Model: Iris/Lilac (Controller Interface Type E)	Date: 15-Nov-99	No.: RA258014a
---	-----------------	----------------

RTB Correction

Subject: SC326 / Abnormal Image		Prepared by: T. Itoh	
From: Technical Service Dept., GTS Division			
Classification:	<input checked="" type="checkbox"/> Troubleshooting	<input type="checkbox"/> Part information	<input type="checkbox"/> Action required
	<input type="checkbox"/> Mechanical	<input type="checkbox"/> Electrical	<input type="checkbox"/> Service manual revision
	<input type="checkbox"/> Paper path	<input type="checkbox"/> Transmit/receive	<input type="checkbox"/> Retrofit information
	<input type="checkbox"/> Other ()

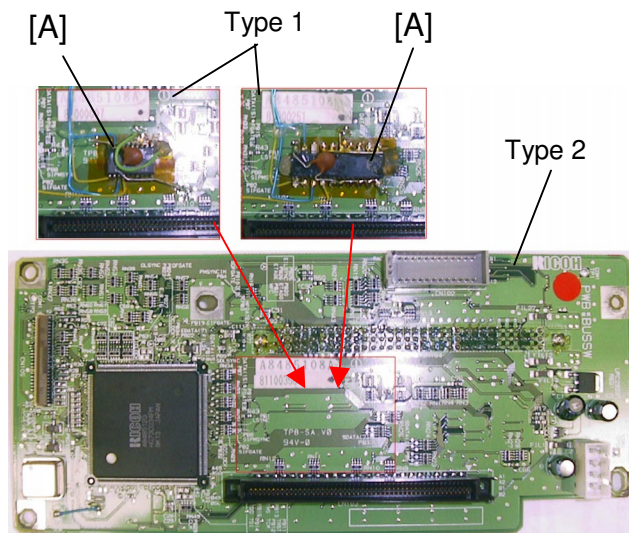
As shown in the picture, there are two types of BUSSW board (P/N #A8485108). Type 1 is the board on which an IC [A] has been manually soldered. Type 2 contains an IC18 soldered onto the circuit pattern by machine.

Type 1 is the board that was modified in the production (from #A8485105). This board contains one of the two ICs as shown in the picture to the right [A]. The only difference is in the size.

The function of the additional IC and IC18 is exactly the same. IC18 is soldered onto the reverse side of the Type 2 board.

[2] Follow the procedure below at installation or next visit to prevent any future occurrence.

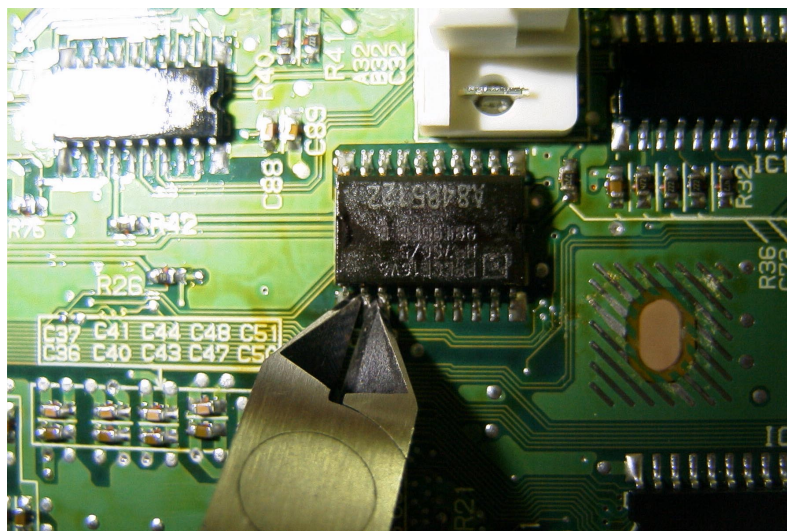
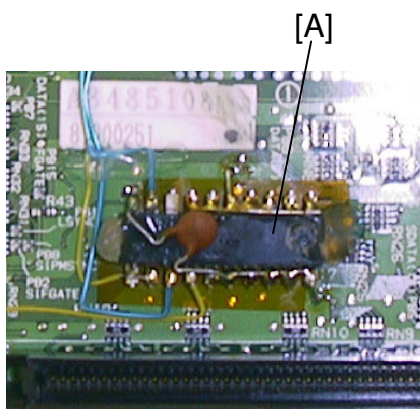
If the BUSSW board contains an IC [A], that has been manually soldered on, the procedure described below is not applicable. The BUSSW board would need to be replaced with #A8485112 when the problem occurs.

NOTE: Be careful not to damage the PCB pattern or cut other pins. If pins #11 or 18 are cut, this will cause SC326.

1. Remove the BUSSW board by following the procedure described on the previous page.
2. Using small cutting pliers, cut pins #12 to 17 so that they do not touch other pins or patterns. This will prevent a short circuit.
3. Remove the cut pins from the board surface.
